# PREVOST

## WARRANTY BULLETIN

WB12-35

DATE : NOVEMBER 2012	SECTION :	22 - HVAC
EXPIRATION: NOVEMBER 2014		
SUBJECT : PRE-HEAT EXHAUST TUBE CLEARANCE

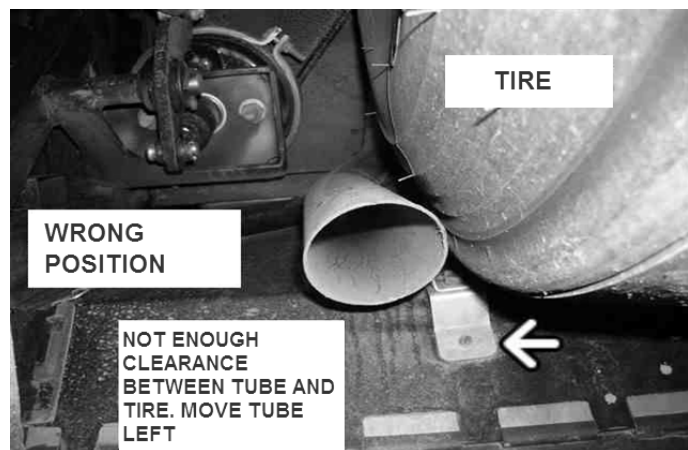
2. Inspect the clearance between the Pre-heater exhaust tube and the tag axle tire.

3. This is the correct position. Distance between tube and tire should be approximately 2 in.

*If the tube shows this position, end the procedure.*

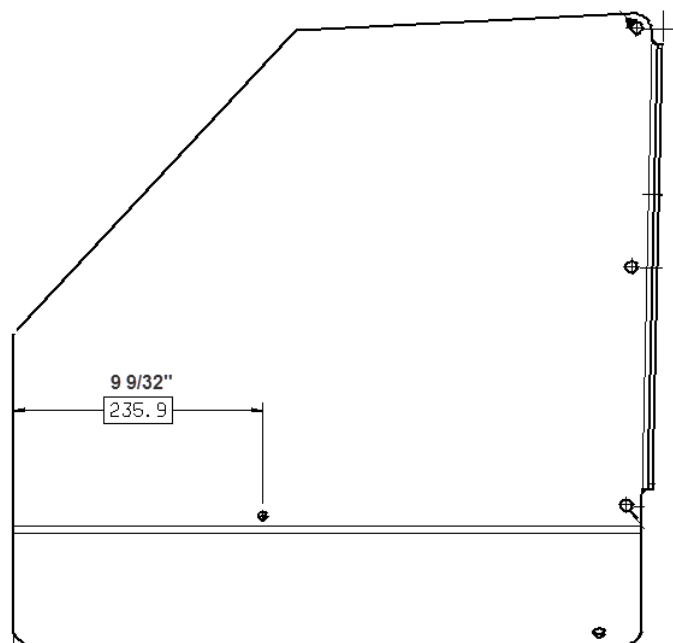
7. To help position the mounting bracket, there is a mark that indicates the proper mounting hole position on the plastic panel.

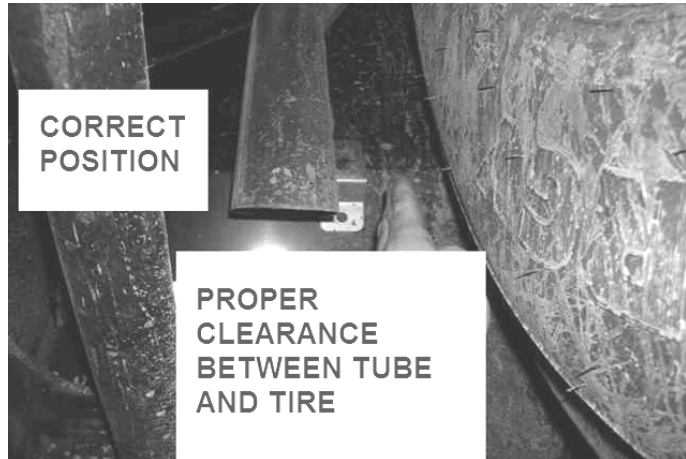
8. Secure at new position. Re-use mounting hardware.

9. The final position should look like this.
